CP-201400401
TXX-14048

SUBJECT: Comanche Peak Nuclear Power Plant (CPNPP) Docket Nos. 50-445 And 50-446 Submittal of Requested Information Regarding Fukushima Lessons Learned - Flooding Hazard Reanalysis Report (TAC NOS. MF1099 and MF1100)

- Attachment Comanche Peak Nuclear Power Plant (CPNPP) Response to Request for Additional Information Regarding Flooding Hazard Reevaluation Report (Non-Proprietary)

Comanche Peak Nuclear Power Plant (CPNPP) Response to Request for Additional Information Regarding Flooding Hazard Reevaluation Report

Figure 2: Comparison of temporal rainfall distributions and discharge using the SCS UH Method, including rainfall losses (see note at bottom of Figure 2)

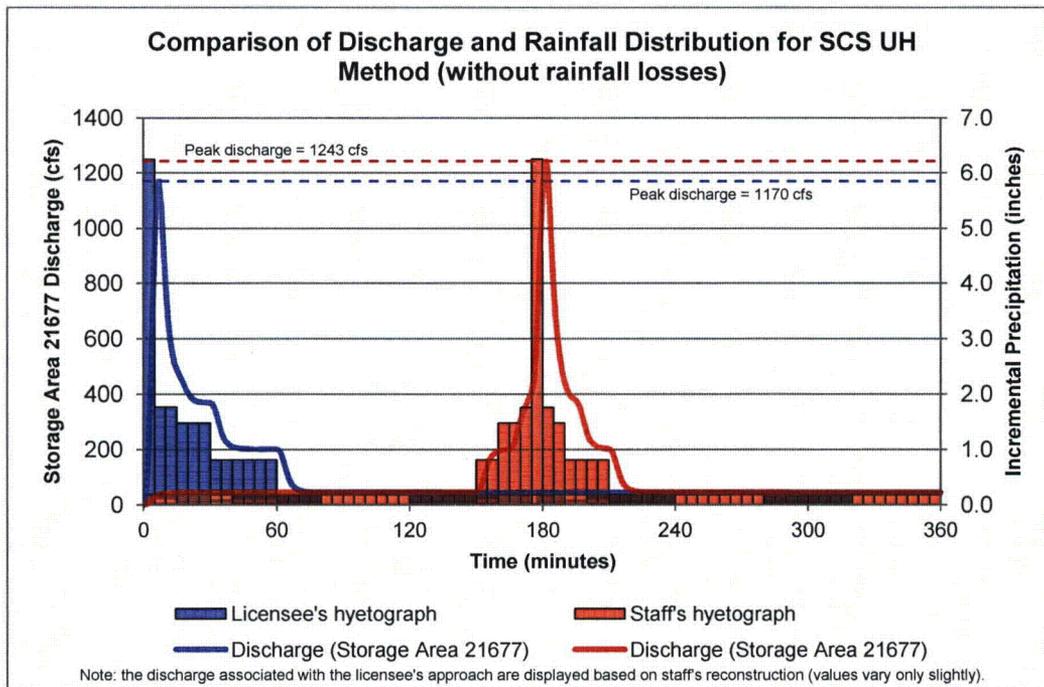
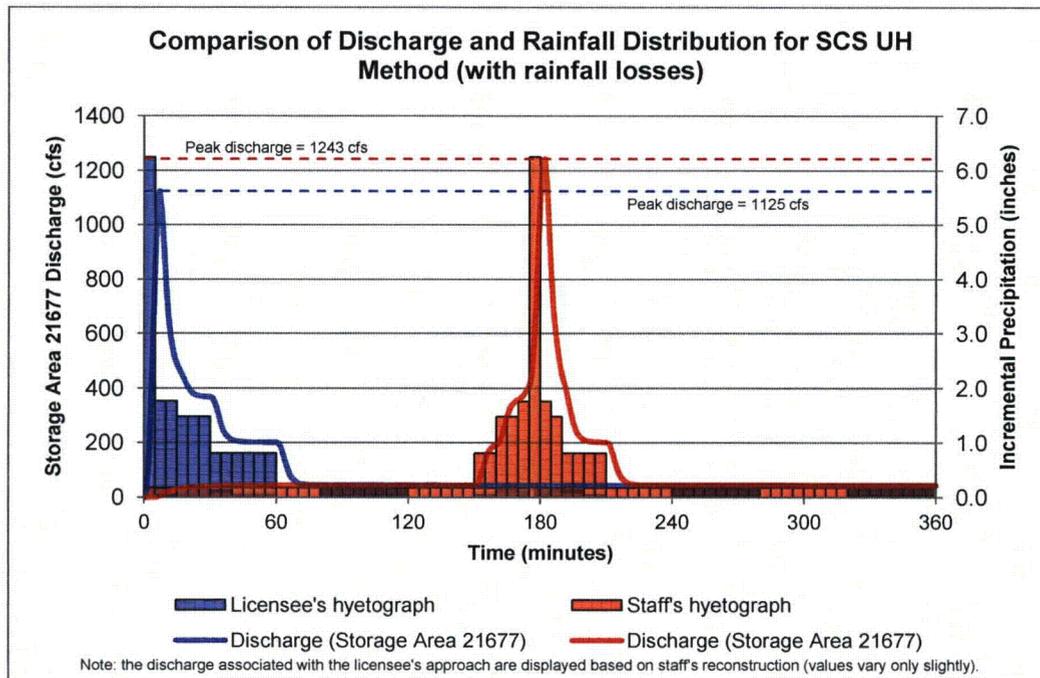
The NRC staff analyzed different temporal rainfall distributions and determined that a centered distribution produces higher peak discharge values compared to a descending distribution for a 6-hour (hr) LIP event. Compared to a descending distribution, the staff's analysis determined that a centered rainfall distribution using the Soil Conservation Service (SCS) Unit Hydrograph (UH) Method without rainfall losses results in 6.2 percent to 6.8 percent higher peak discharge values. An illustration of temporal PMP and discharge values for both distributions is shown on Figure 1 for Storage Area 21677. According to the staff's analysis, for the SCS UH Method including rainfall losses, peak discharge values using a centered distribution, range from 9.3 percent to 23.4 percent, higher than those from a descending distribution. An illustration of temporal PMP and discharge values for both distributions is shown on

Figure 2 for Storage Area 21677. While a centered distribution appears to bound a descending distribution, other arrangements (such as a two-thirds distribution) may produce even higher water levels. Based on the review, the NRC staff requests for the following information:

- A. Technical rationale for assuming a descending distribution for LIP analysis.
- B. Documentation of any sensitivity analysis performed in analyzing the PMP, drainage discharge, and water levels associated with local intense precipitation flooding.

A descending rainfall distribution, with the highest rainfall intensities early in the event, was used in Calculation F-03 (Reference 5) in support of the FHRR in accordance with the method used in Appendix B of NRC NUREG/CR-7046 (Reference 4, Figure B-5).

Sensitivity analyses (beyond the implementation of the Hierarchical Hazard Assessment [HHA] methodology) were not conducted using different rainfall distributions for the LIP analysis.

FIGURE 20-1
FLOOD DURATION OF STORAGE AREA 21669 FOR 6-HOUR PMP, SC4 OF LIP

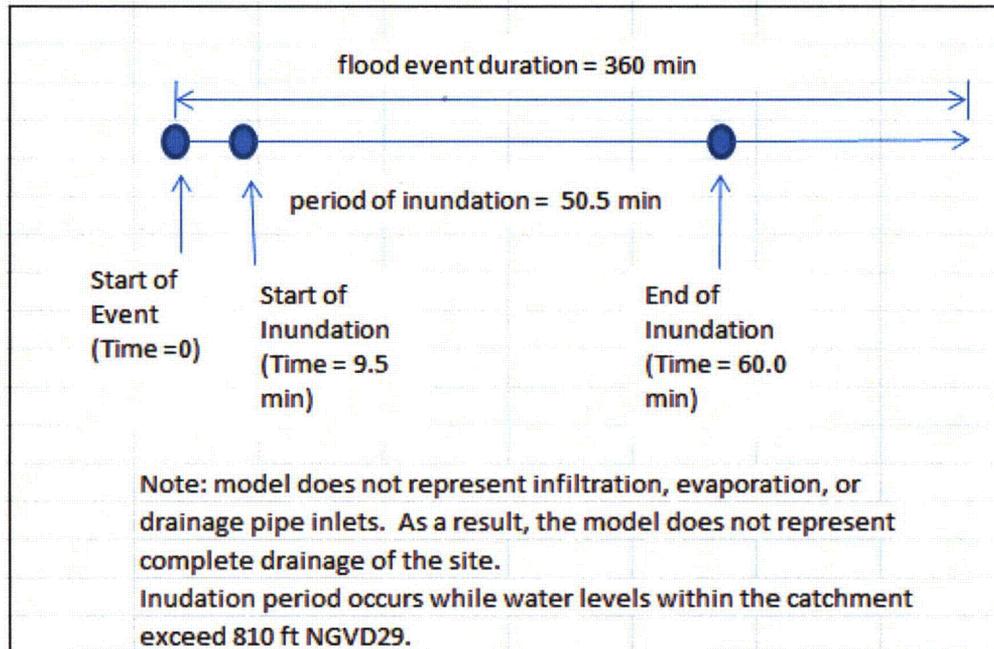
The licensee is requested to provide the applicable flood event duration parameters (see definition and Figure 6 of the Interim Staff Guidance (ISG) JLD-ISG-2012-05, "Performing of an Integrated Assessment," dated November 30, 2012 (ADAMS Accession No. ML 12311A214) associated with mechanisms that trigger an integrated assessment using the results of the flood hazard reevaluation. This includes (as applicable) the warning time the site will have to prepare for the event (e.g., the time between notification of an impending flood event and arrival of floodwaters on site) and the period of time the site is inundated for the mechanisms that are not bounded by the current design basis. Please provide the basis or source of information for the flood event duration, which may include a description of relevant forecasting methods (e.g., products from local, regional, or national weather forecasting centers) and/or timing information derived from the hazard analysis.

Figure 20-1 is provided below in response to RAI 20. A figure is not provided for river flooding (and combined effects) because the plant site grade of 810 ft NGVD29 and applicable safety related SSCs are not inundated by the river flooding event. Figure 20-1 shows the length of time water surface elevations remains above elevation 810 ft NGVD29 for the storage area which leads to the highest water surface elevations around the site.
